Peter Drown
Cleantech Analytics
6717 Cub Run Court
Centreville, VA 20121

January 9, 2019

Subject: Recertification Recommendation for the Silver Lake Hydroelectric Facility (FERC # 11478, LIHI #91)

Figure 1 - Zones of Effect Map

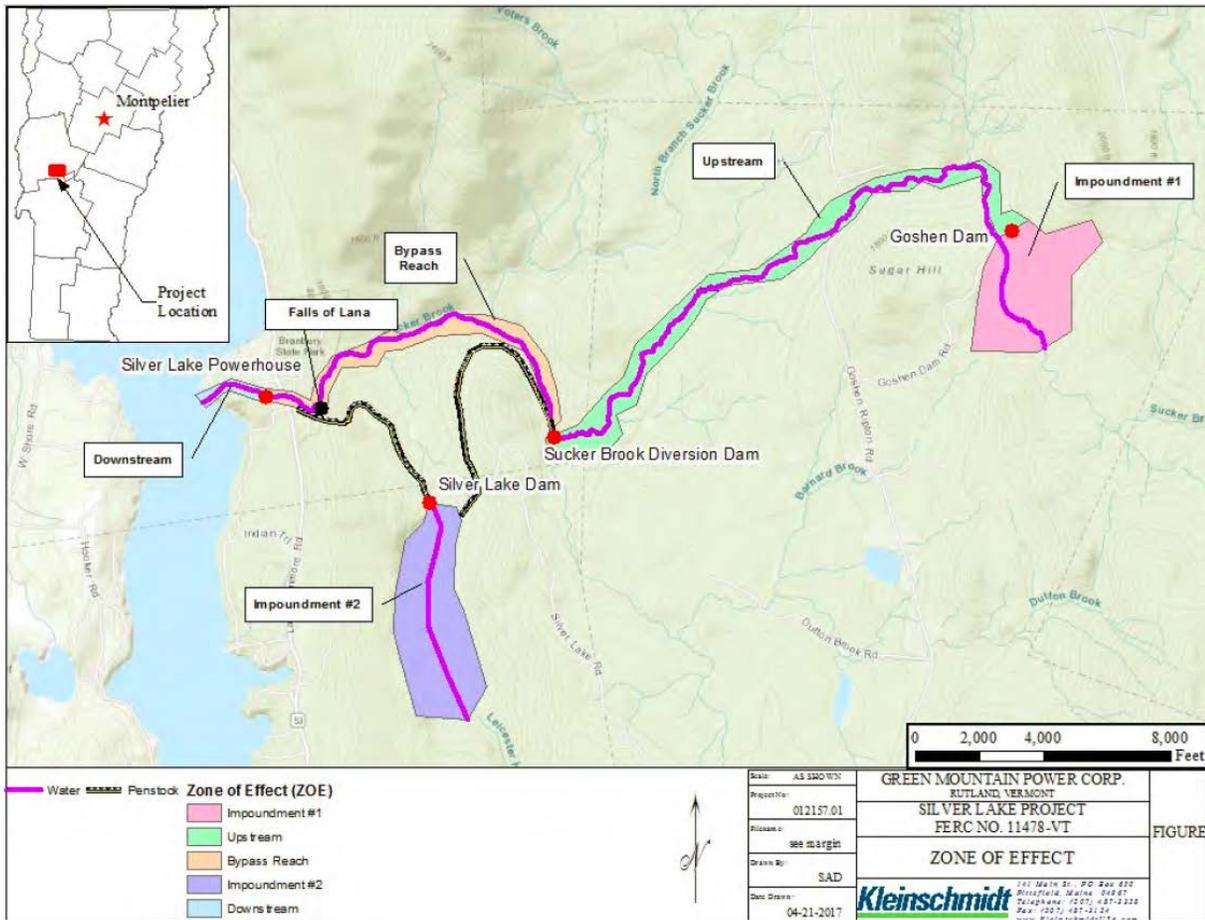
In my opinion, the Applicant properly selected five zones of effect for the Facility (Figure 1). The Applicant defined the following zones:

- Zone 1) Impoundment #1 = Sugar Hill Storage Reservoir;
- Zone 2) Upstream = Goshen Dam to Sucker Brook Diversion Dam;
- Zone 3) Bypassed Reach = Sucker Brook Diversion Dam to Silver Lake Powerhouse;
- Zone 4) Impoundment #2 = Silver Lake;
- Zone 5) Downstream = Silver Lake Powerhouse to Lake Dunmore.

Figure 4 - Downstream Zones of Effect

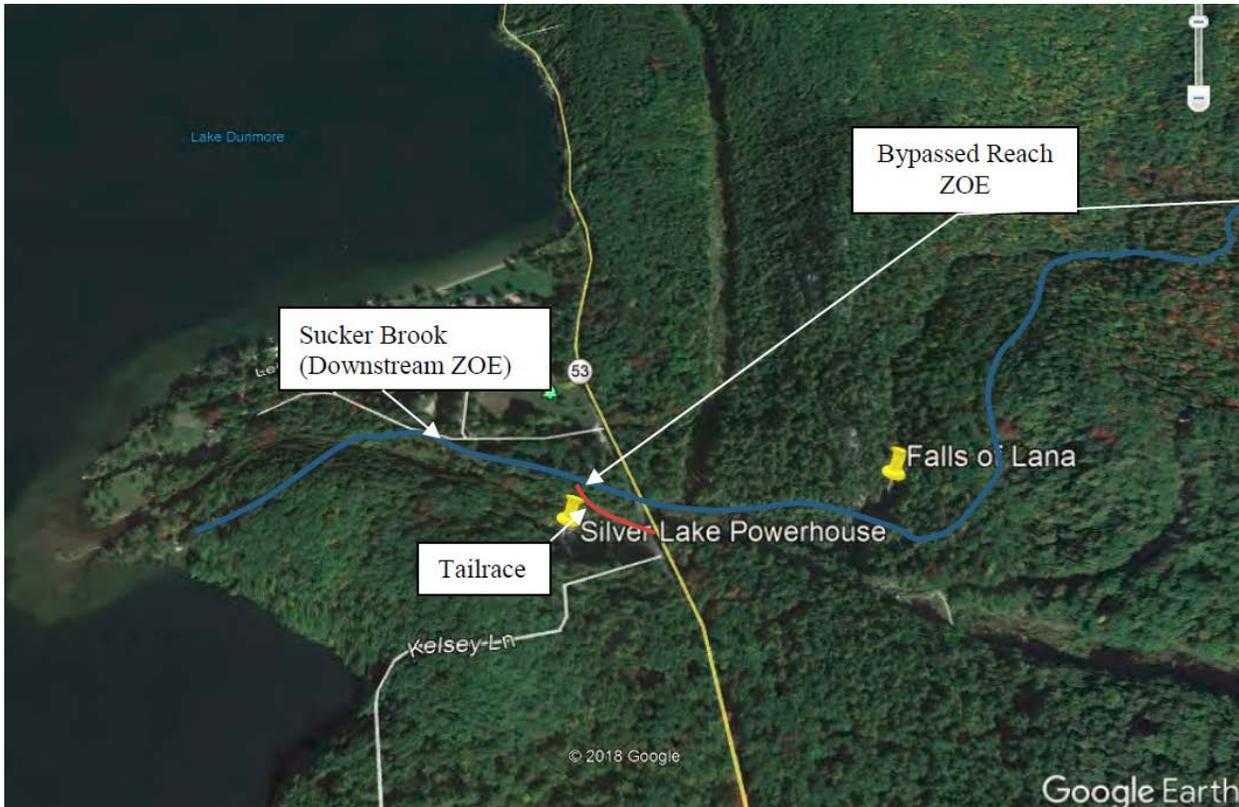
Figure 4 below provides a closer view of this downstream zone that is important for safe fish passage. The area from the Project tailrace to Sucker Brook’s confluence with Lake Dunmore provides a short riverine stretch where landlocked Atlantic Salmon, brook trout, rainbow trout, and lake trout can access spawning habitat. There is a small section between the natural barrier of the Falls of Lana and the Silver Lake Powerhouse tailrace that species can also access, and landlocked salmon have occasionally been observed in this reach by GMP staff. To prevent fish from moving past the tailrace and entering the Silver Lake powerhouse, GMP maintains a vertical fish exclusion rack and screen device at the tailrace. Furthermore, GMP is required to operate the turbine in that powerhouse at a reduced capacity or offline completely during smelt spawning season in the spring. When the turbine is brought offline, GMP is required to maintain an incremental ramping sequence to prevent stranded species and allow safe species egress during the down-ramping period. These requirements are all required as conditions in the Water Quality Certificate, and meet LIHI’s definition of Agency Recommendation. The Owner adequately demonstrated compliance with agency recommendations for the downstream zone.
